MEMORANDUM

SUBJECT: BASF Wyandotte Corporation

The comments relevant to hydrogeology, so far, are:

Sketch 1

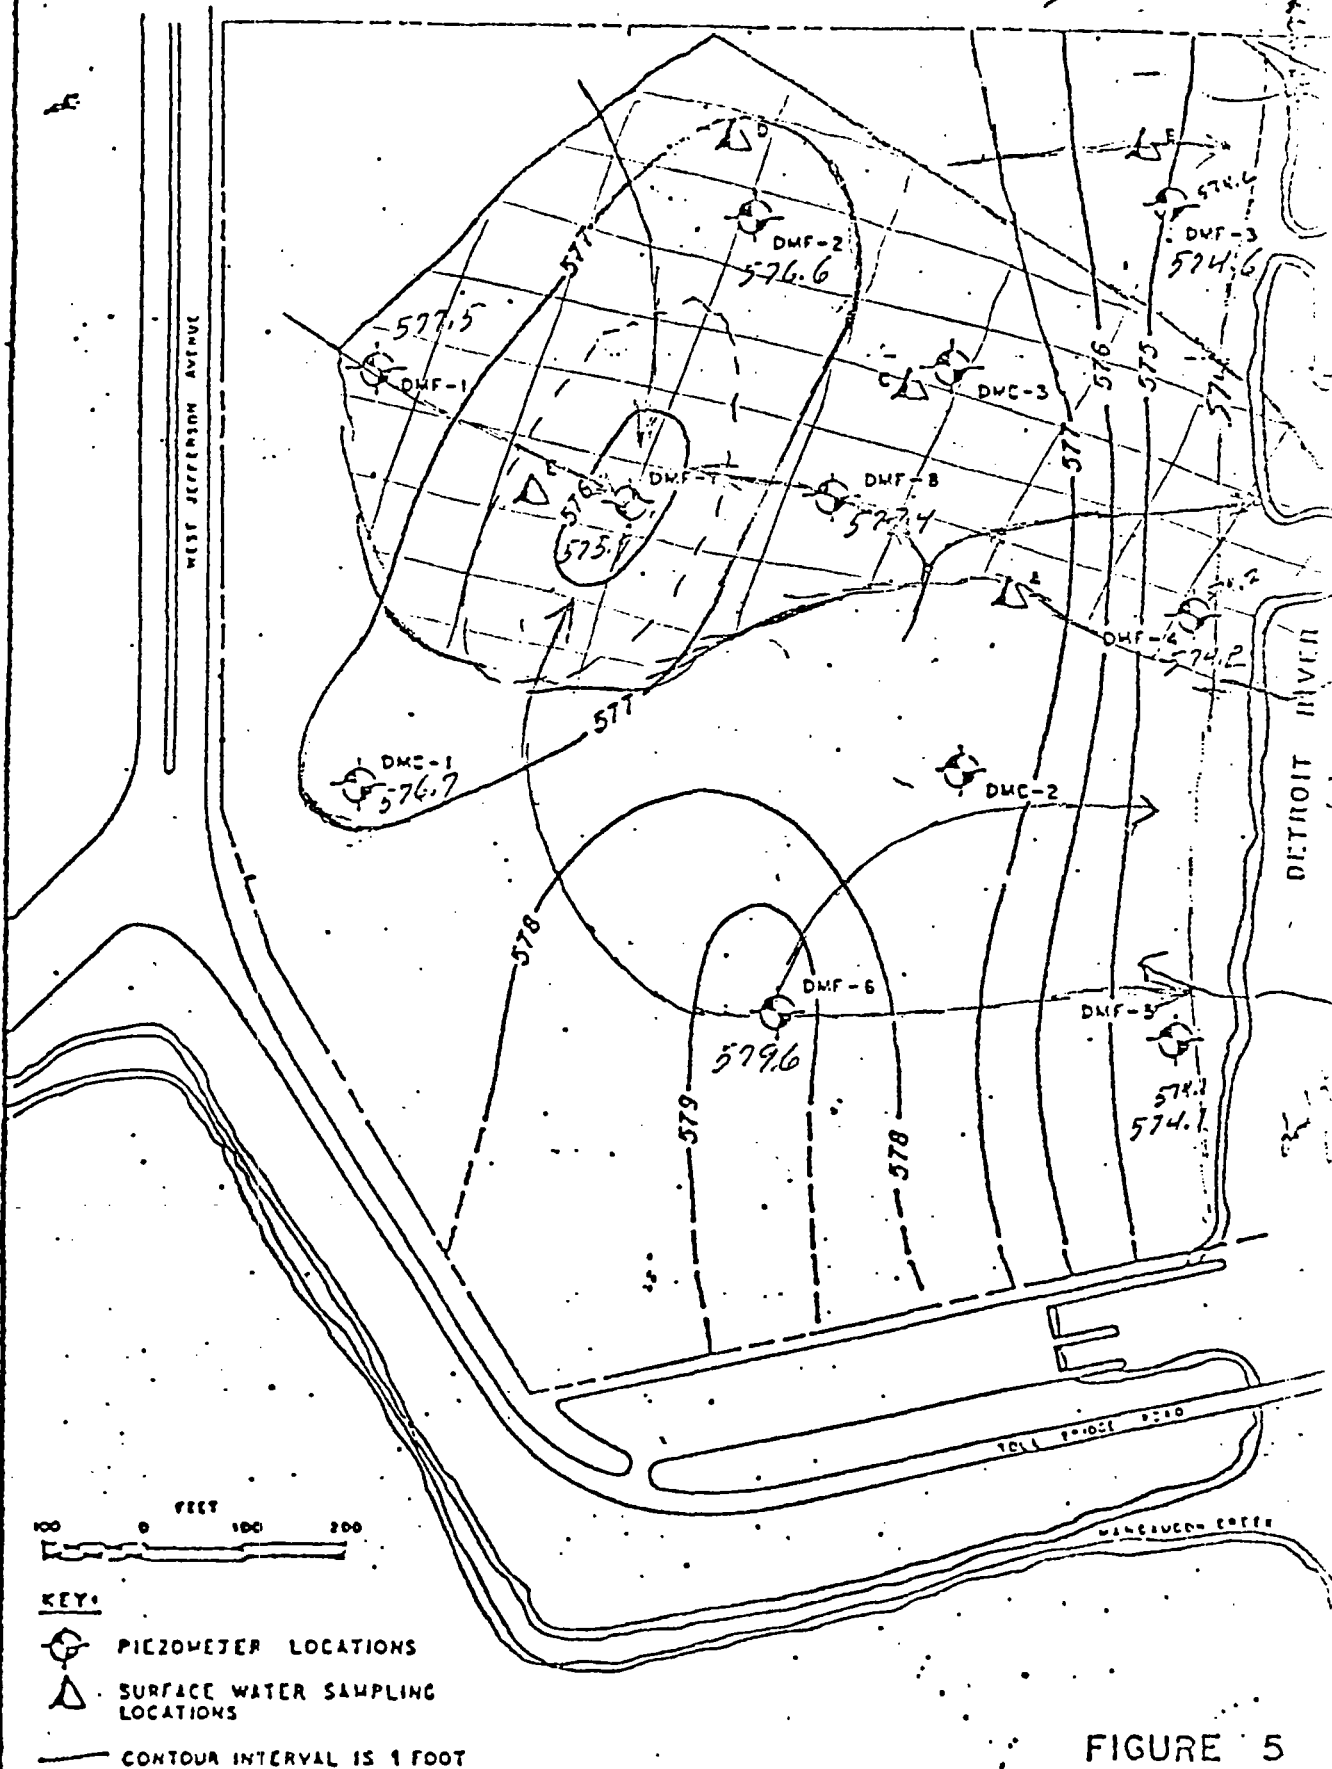
3. Attachment B - Why does the overlay of the zone of contamination extend into the Detroit River? Did the landfill at one time lie where the channel is today? What are the characteristics of well #17. Is it an actively pumping well, monitoring well, or what? Groundwater flow appears by one interpretation to be flowing SE toward #17 and NW, also toward #17, from the east. Why is point 17 called a well on the map and a "pit" less than 4 ft. deep on p. 15? See Sketch 1.

FIGURE 5  
POTENTIOMETER  
SURFACE (MARCH)  
DAMES

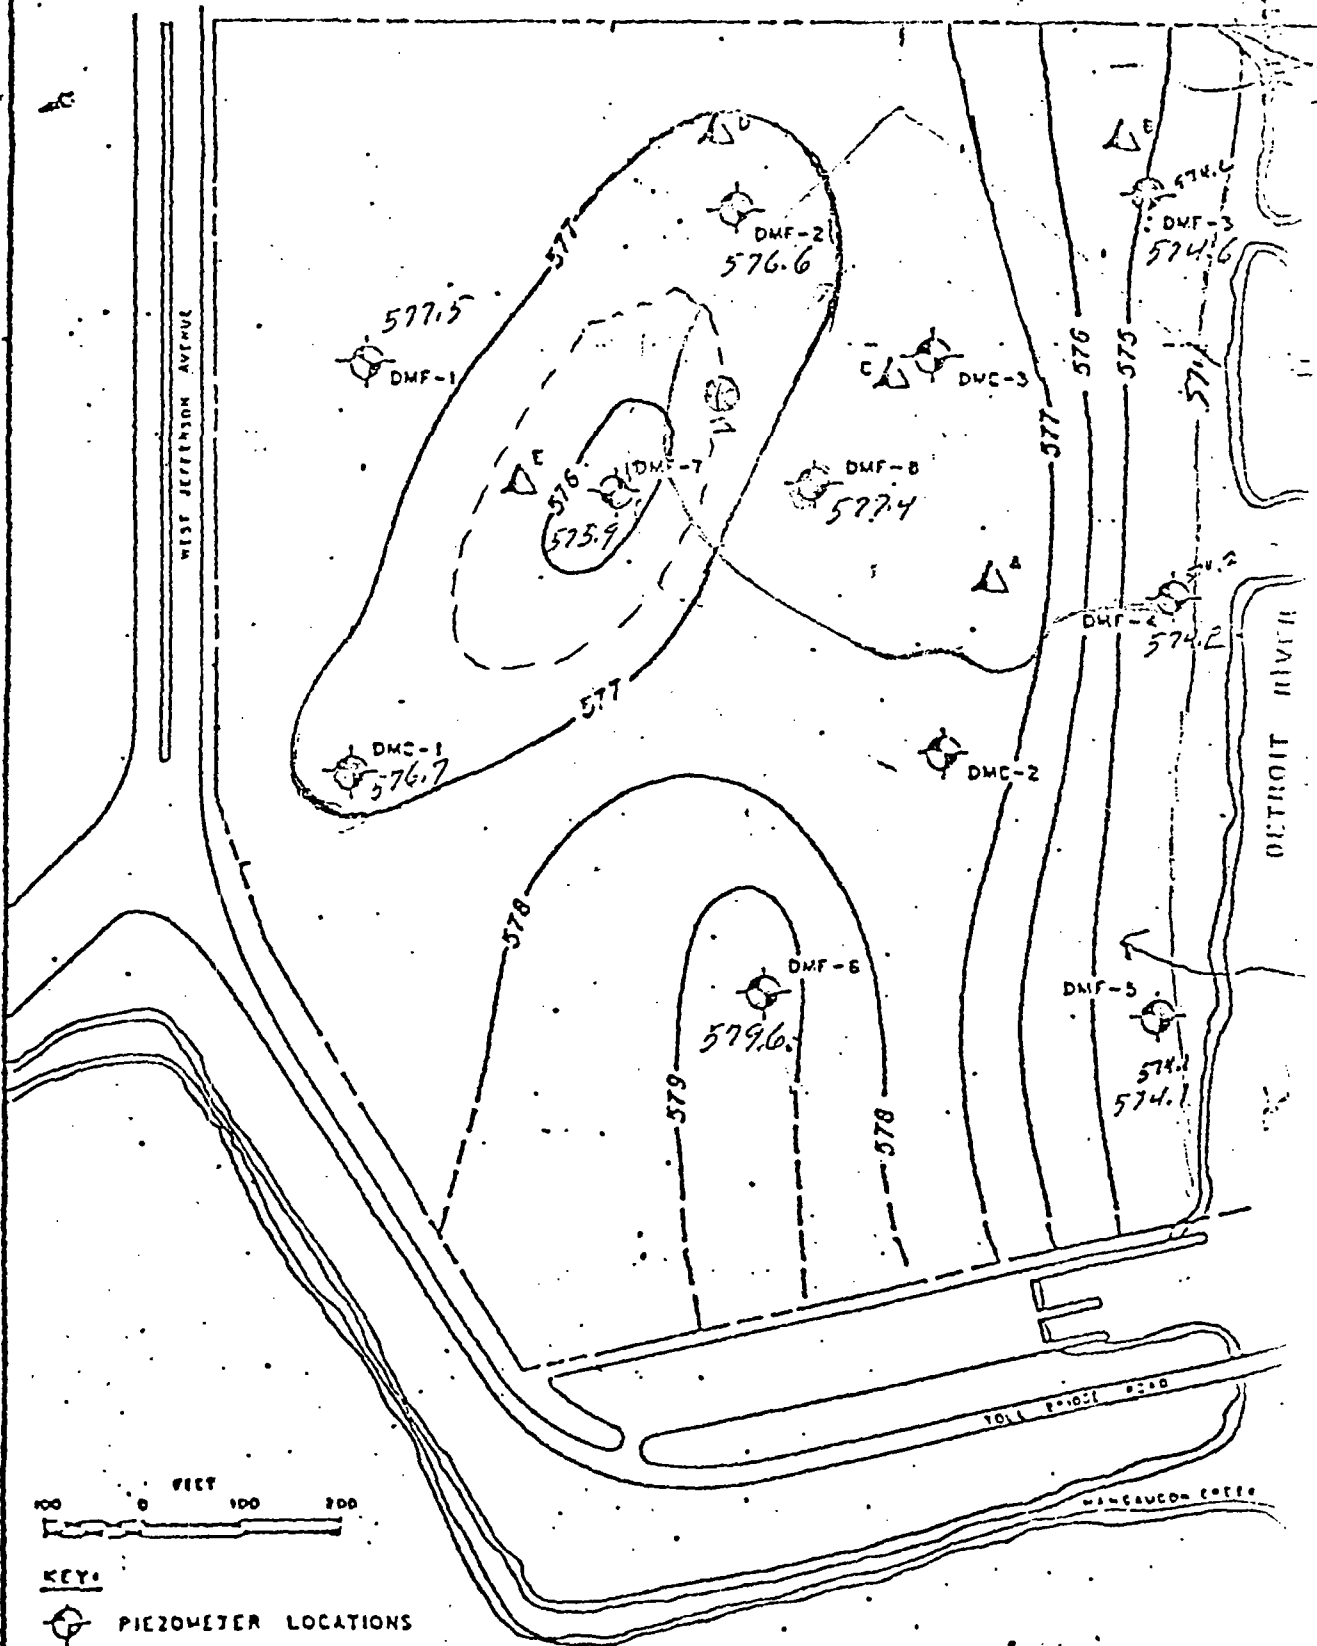
- e. According to AER's report a Zone of Contamination can be drawn onto the plat. Scaling this area onto the sketch's of D&M the deepest fill and the lowest potentiometric surface both plot in the center of the area. One boundary line is very close to DMF 4. This needs investigation. If the potentiometric surface at DMC 3 is not an error, or the surface did not have time to rise to its proper level then a drop of 19.7 ft. (gradient = 0.136) is indicated. This is of great variance from the normal range for the site.

- f. There is no fill isopach for DMF 3 and DMF 4 Fig. 3
- g. An alternate Fig. 5 potentiometric surface sketch can be derived.
- h. An alternate Fig. 4, topographic surface of the fill clay interface can be drawn. This one more dramatically illustrates the possibility of the ancestral creek and exhibits more Channelization. Note also that the "channel" leads to the contamination zone and exits the site just north of DMF 4.

FIGURE 4  
TOPOGRAPHIC SURFACE  
OF THE FILL - CLAY  
LAYER INTERFACE  
DAMES & MOORE

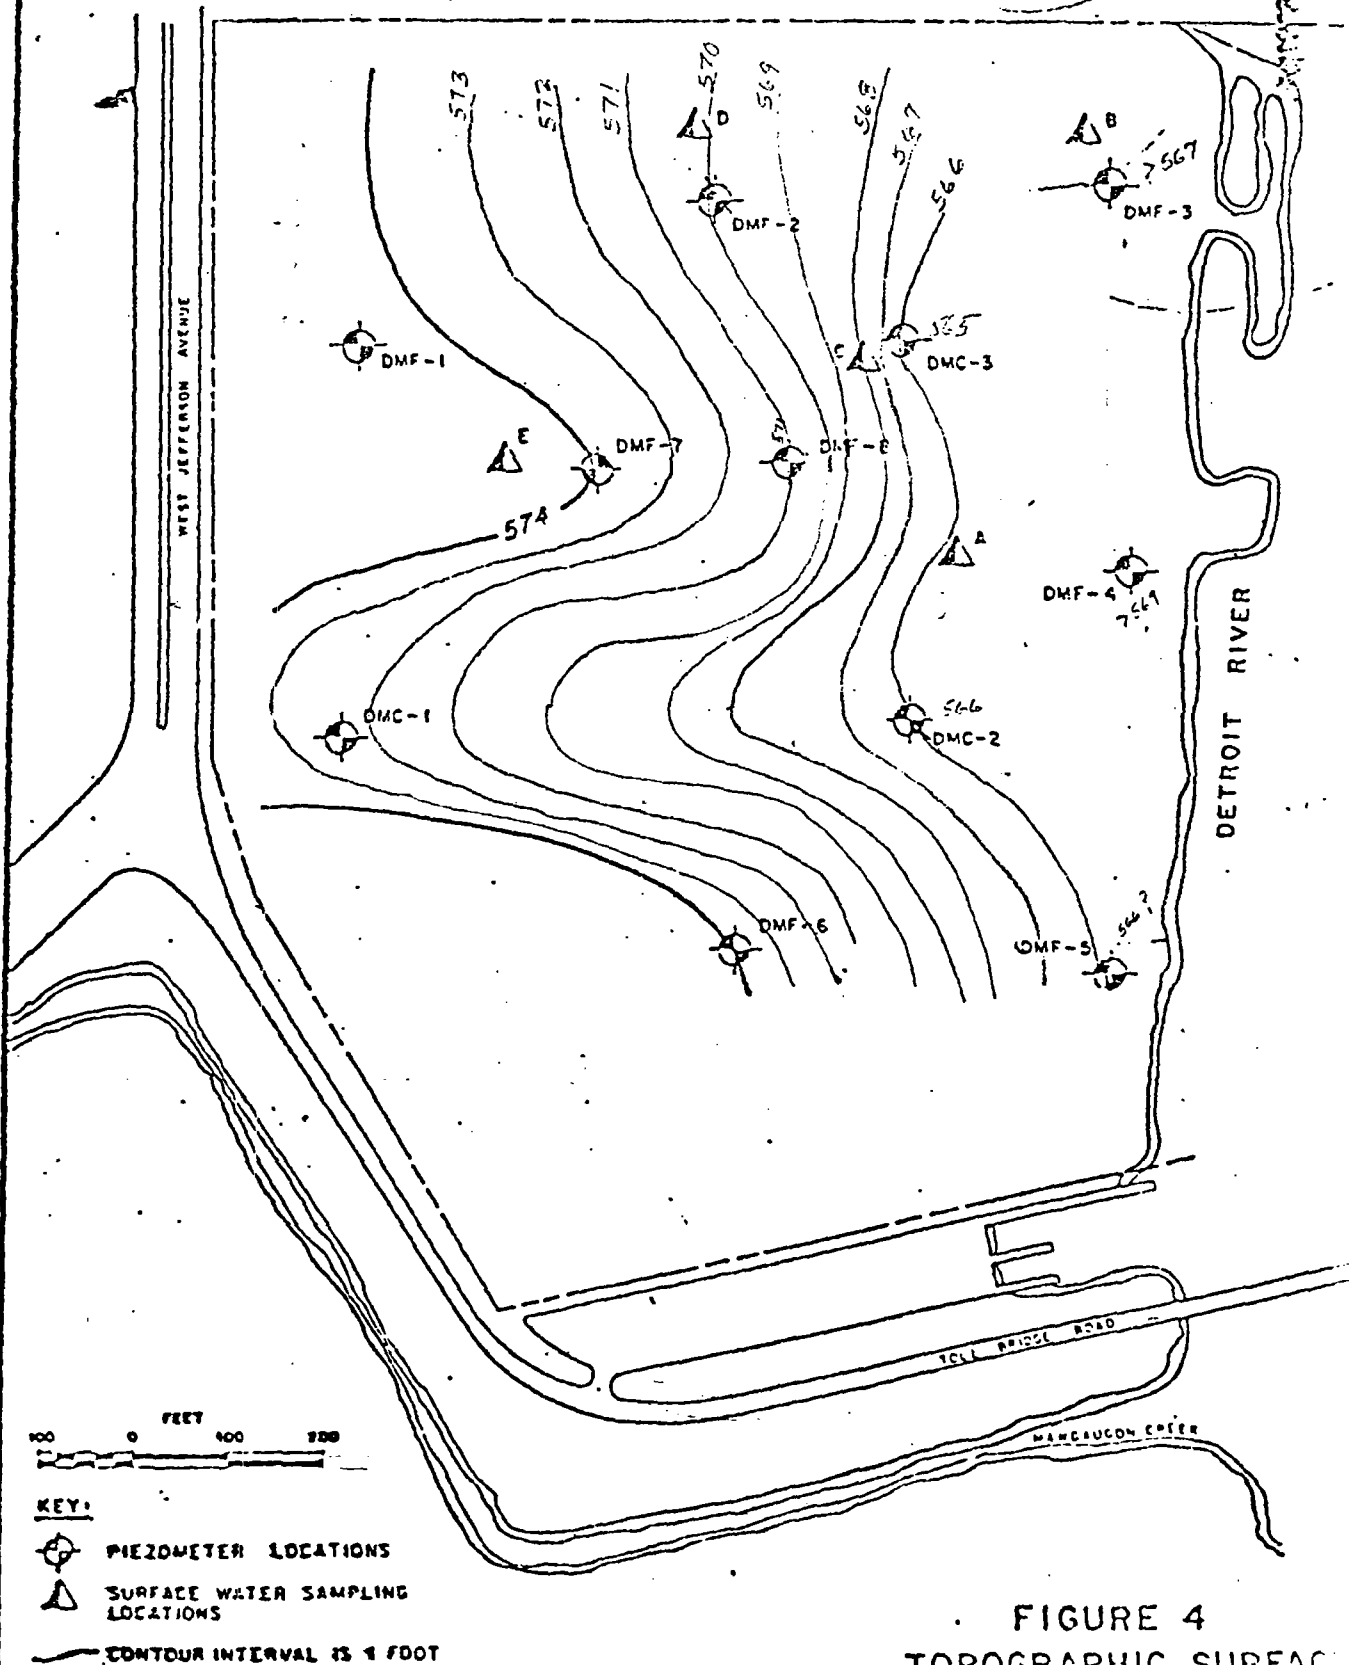
1. The depth of fill in the site does range from approximately 3 feet in the N.W. corner to over 14 feet and is unknown for the entire length of the site along the river, except in the vicinity of DMF5. There it appears to be 12.5 ft. FIG 4.
